STAFF REPORT
DATE: 12/12/2023
WORKSHOP Discussion

TO: City Council
FROM: Nathan Fuerst, AICP, Consulting Planner
AGENDA ITEM: **Sketch Plan Review – Limerick Village**
REVIEWED BY: Jenni Faulkner, Senior Consulting Planner
Sophia Jensen, City Planner

RE: Limerick Village Sketch Plan Review

To: Sophia Jensen, City Planner
Cc: Jenni Faulkner, Planning Consultant
Dutin Kalis, Fire Chief
Chad Isakson, PE, Assistant City Engineer
From: Jack Griffin, PE, City Engineer
Re: Limerick Village Concept Plan
PID 3602921420001 / 3602921410001

Density Exhibit

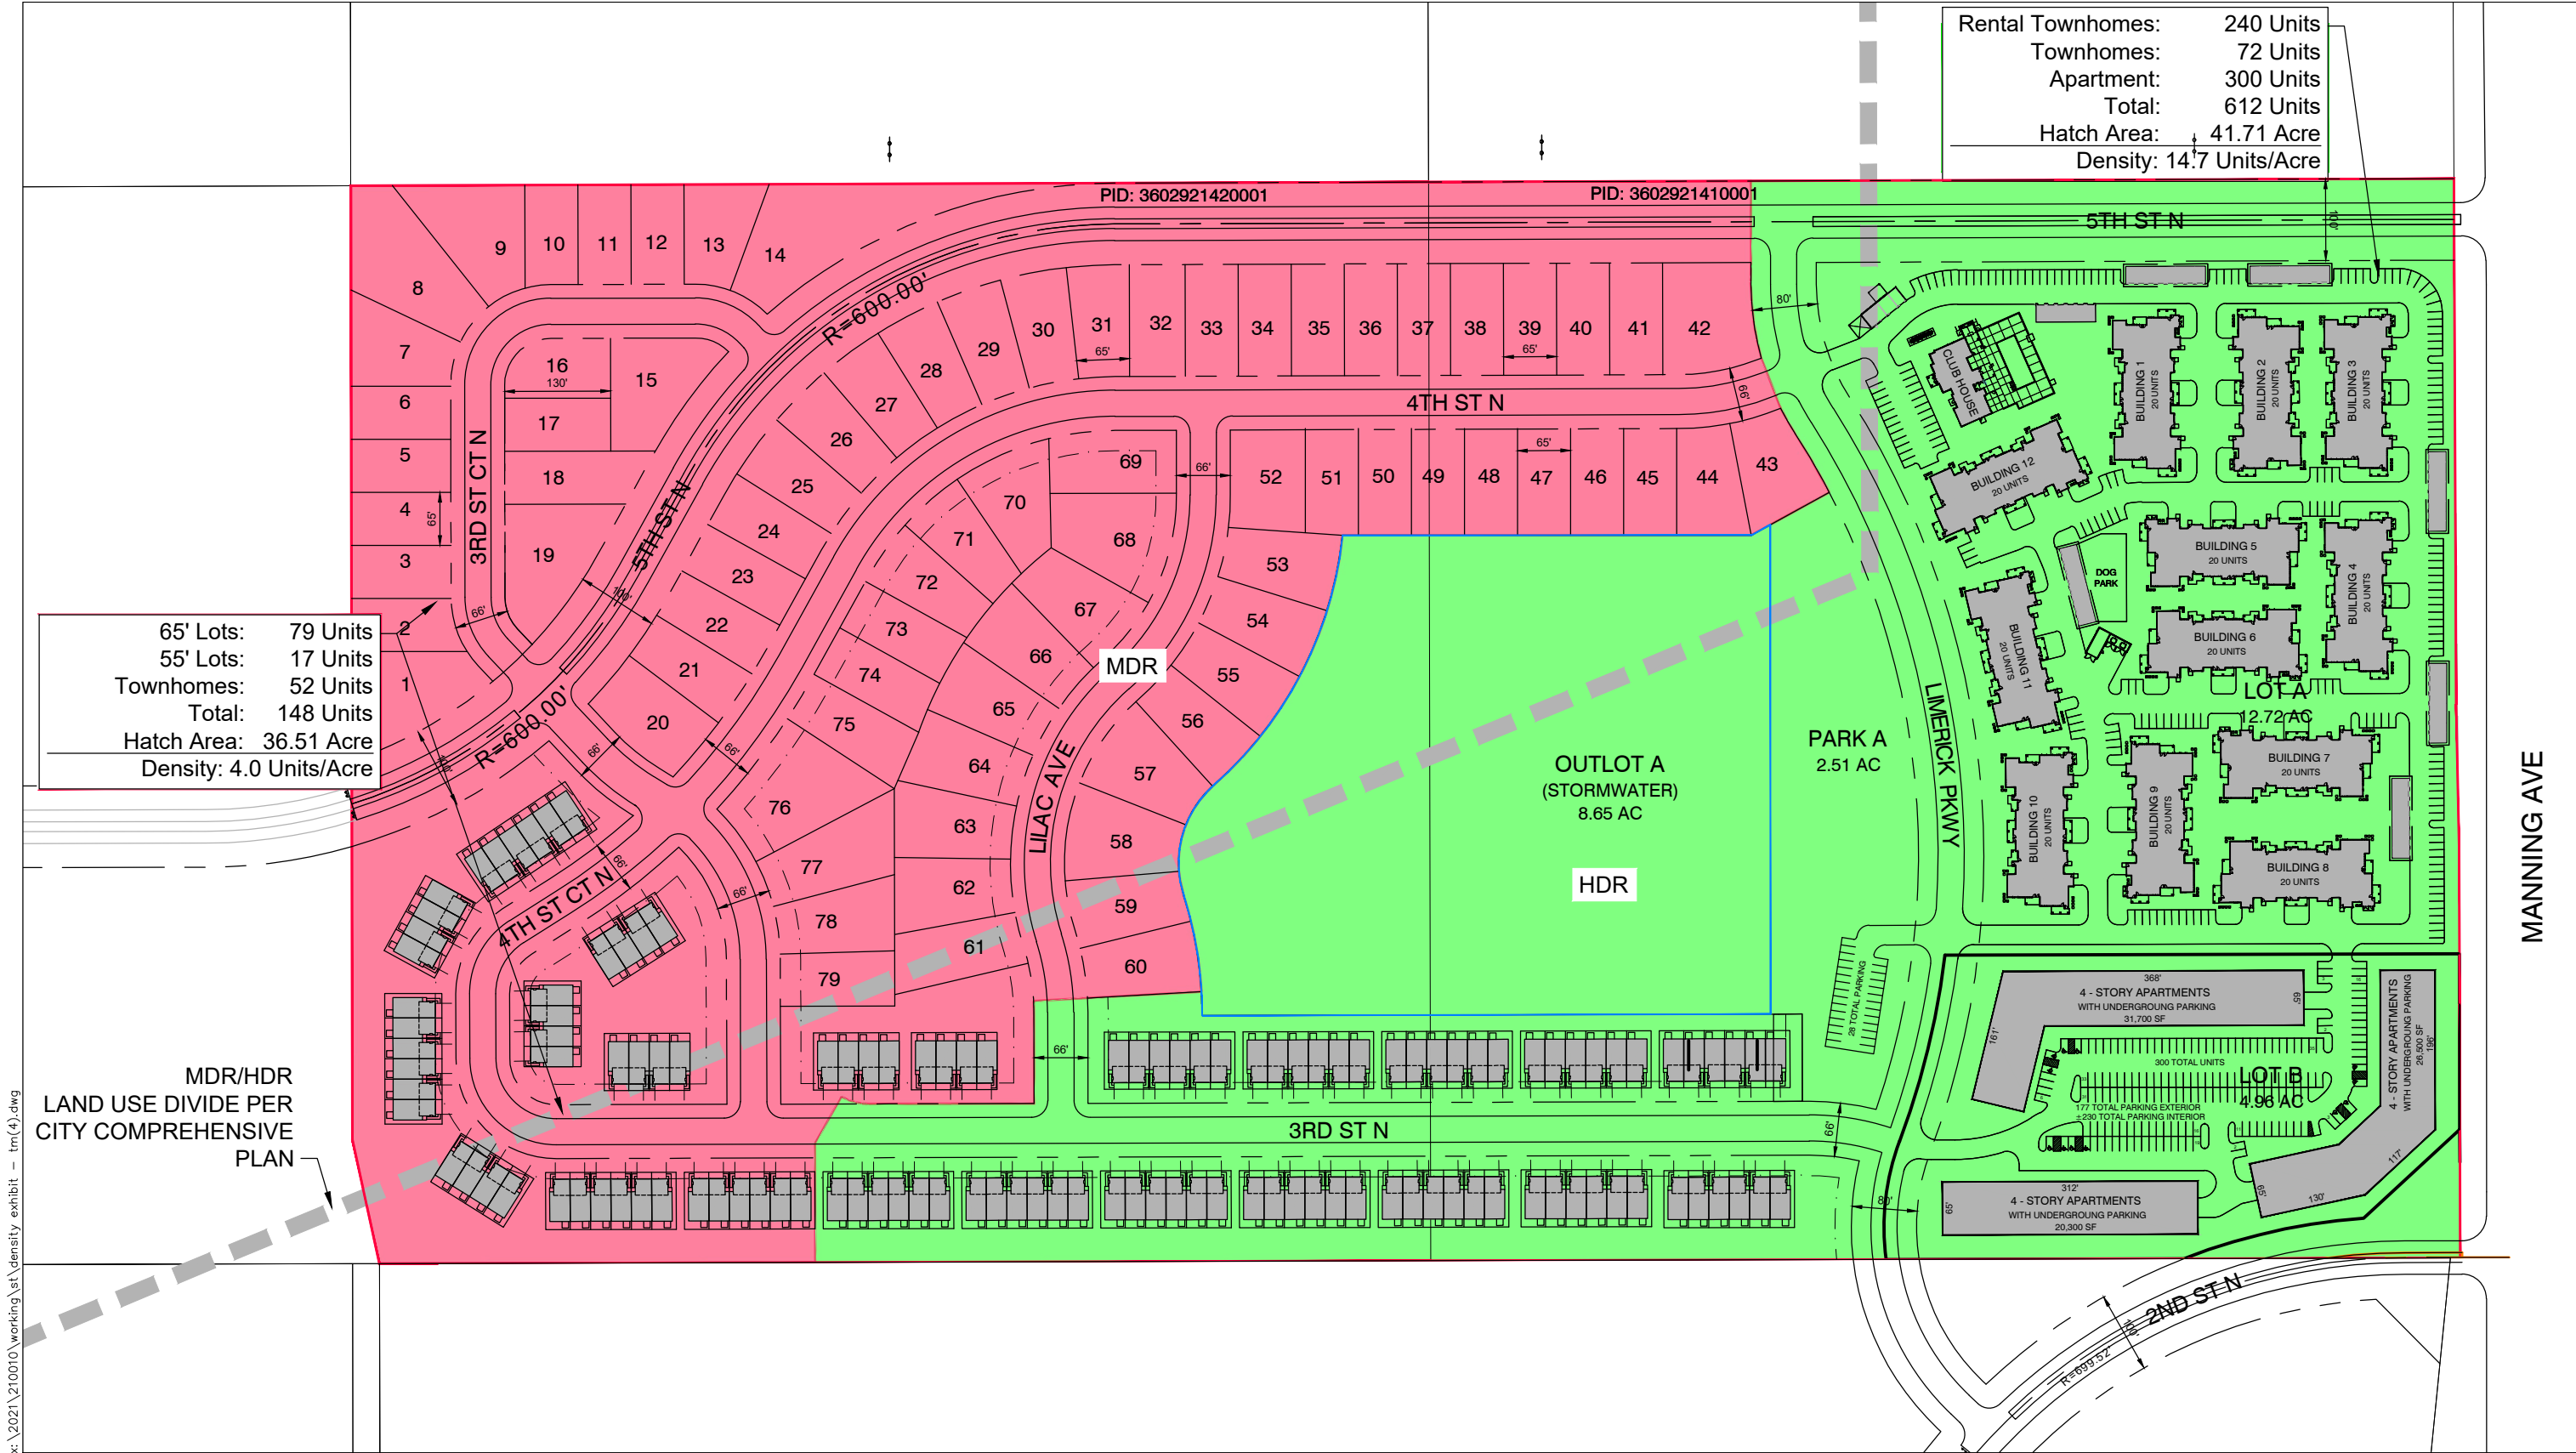
1. Density in MDR/HDR areas – the densities in the proposed areas must be consistent with the range allowed in the 2040 Comprehensive Plan. The proposal is just meeting the

minimum density for the MDR acreage and is over for the HDR acreage. (Explain where they are at)

The Developer has been instructed through the concept development process that a Comprehensive Plan Amendment is required by the City to align the future land use categories with the property boundaries proposed in the development. This is required to ensure that the comprehensive plan's map accurately reflects the property post development. As proposed, land areas for both Medium Density Residential (MDR) and High Density Residential (HDR) will contain as close to the same net acreage as presently guided. Generally, the proposal meets the intent of the Comprehensive plan to transition the density from higher on the east to lower on the west.

It is possible that the developer could seek a density bonus under Section 105.12.1160 to address the issue with proposed net density of the HDR land. However, if the density of over 15 units per acre is exceeded, the project wouldn't comply with the comprehensive plan. Additionally, the developer needs to keep the same net land areas for both MDR and HDR land so that the City can continue to comply with Met Council housing policy as described above.

At 760 units on 79.3 gross acres, this concept meets the overall guided density of the City's Comprehensive Plan, which would require a range of units in each Future Land Use Category as broken down below:

*City Staff were advised by Met Council staff that the land to be dedicated as parkland to the City must be netted out of the density figure. Therefore, additional adjustments to the HDR/MDR boundaries and units are expected.

The proposed development will have to keep as close to the same amount of land guided for each use as feasible. Specifically, the amount HDR land outside of the arterial ROW along Manning cannot be reduced. This can be accomplished by a reduction of 2.51 acres from MDR and addition to the HDR. Units will need to be adjusted accordingly.
